Proposed amendment to to the GCU

Title	<i>New pictogram “High voltage warning sign”</i>
Nummer	<i>AP-TTI-2025-12</i>
Planned entry into force	<i>01/01/2026</i>
Related Topic proposal	<i>TP-TTI-2025-12</i>
Proposer / issuing working group	<i>WG TTI Claude Weis</i>
Section of the GCU	<i>GCU Appendix 11</i>
Concise description (Management Summary)	<i>EN15877-1:2024 has introduced a new pictogram “High voltage warning sign”. This must be integrated into GCU Appendix 11</i>

AP-TTI-2025-12

8.2 Signs for high voltage warning sign (Stop!)

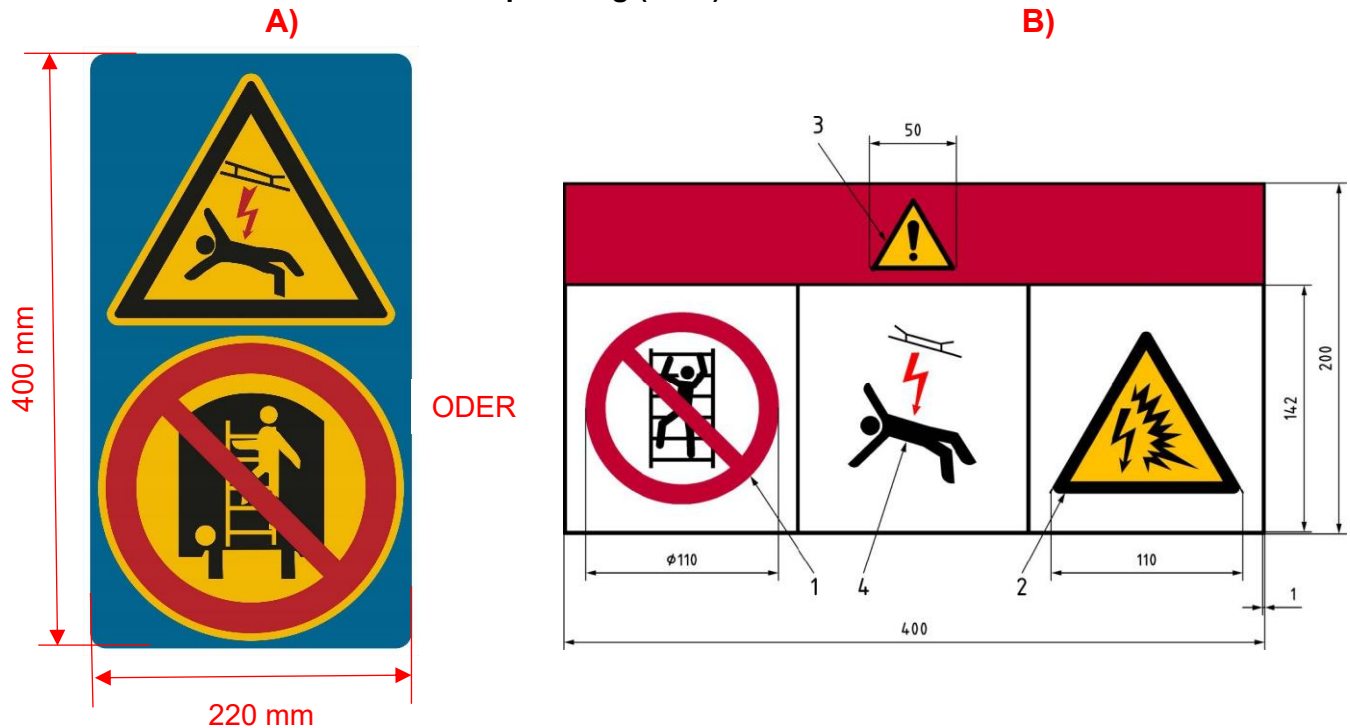
Position: On wagons with steps or ladders, in the immediate vicinity of these fittings and at a height such that the sign is visible before the danger zone is reached. For use on wagons where the top step or upper part of the ladder **for the pictograph A)** is more than **2000 mm** and **for the pictograph B)** upper **1450 mm** above rail level, or whose design enables them to be climbed.

~~This pictogram may be shown on a rectangular blue background measuring 400 mm x 220 mm.~~

~~Note: This marking is mandatory as of 1/1/2021.~~

8.2 Warnzeichen für Hochspannung (Halt!)

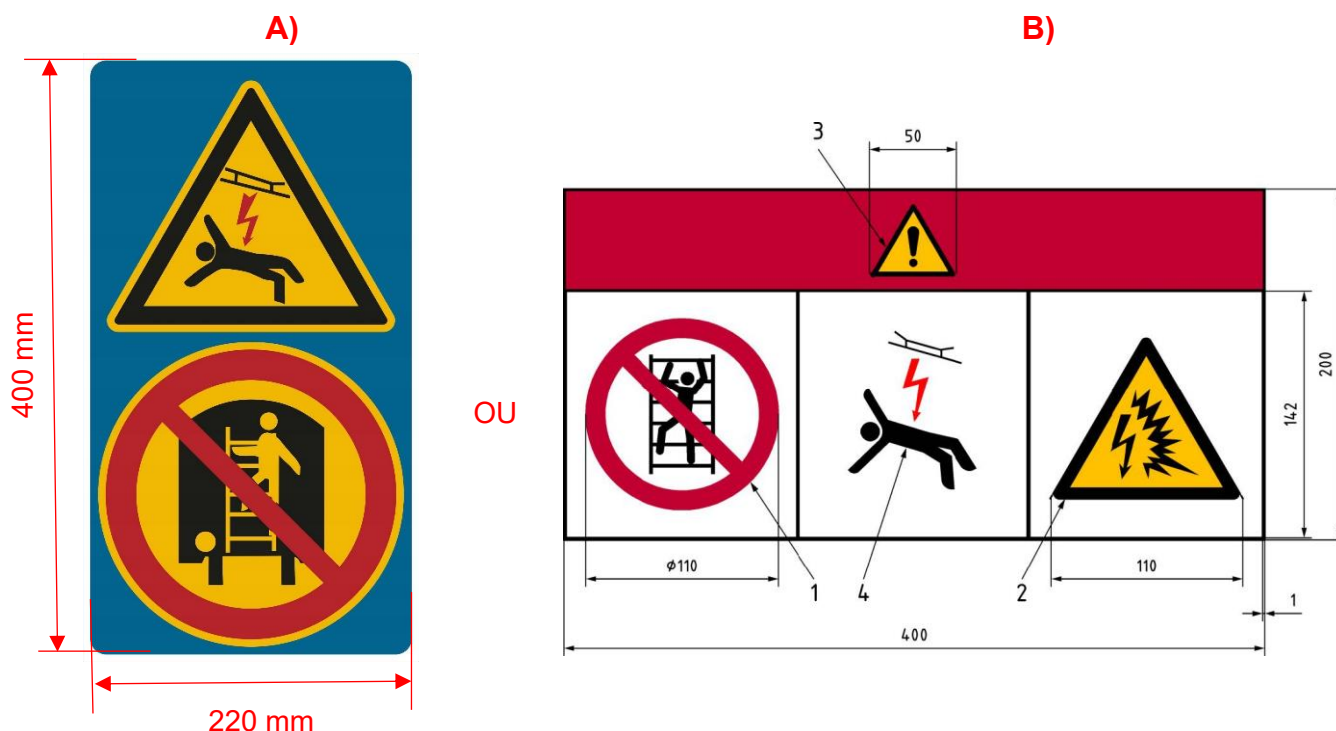
Anordnung: An Wagen mit Aufstiegstritten oder Leitern in deren unmittelbarer Nähe, und zwar in einer Höhe, dass das Zeichen vor Erreichen der Gefahrenzone gesehen werden kann. Anzubringen bei Wagen, bei denen der oberste Aufstiegstritt oder die oberste Leitersprosse für das Piktogramm A) höher als 2000 mm und für das Piktogramm B) höher als 1450 mm über der Schienenoberkante liegt oder bei Wagen, deren Aufbau ein Aufklettern ermöglicht.

~~Diese Kennzeichnung darf auf einem blauen rechteckigen Hintergrund mit den Abmessungen 400 mm x 220 mm dargestellt werden.~~

~~Beachten: Diese Anschrift ist ab dem 01.01.2021 verpflichtend.~~
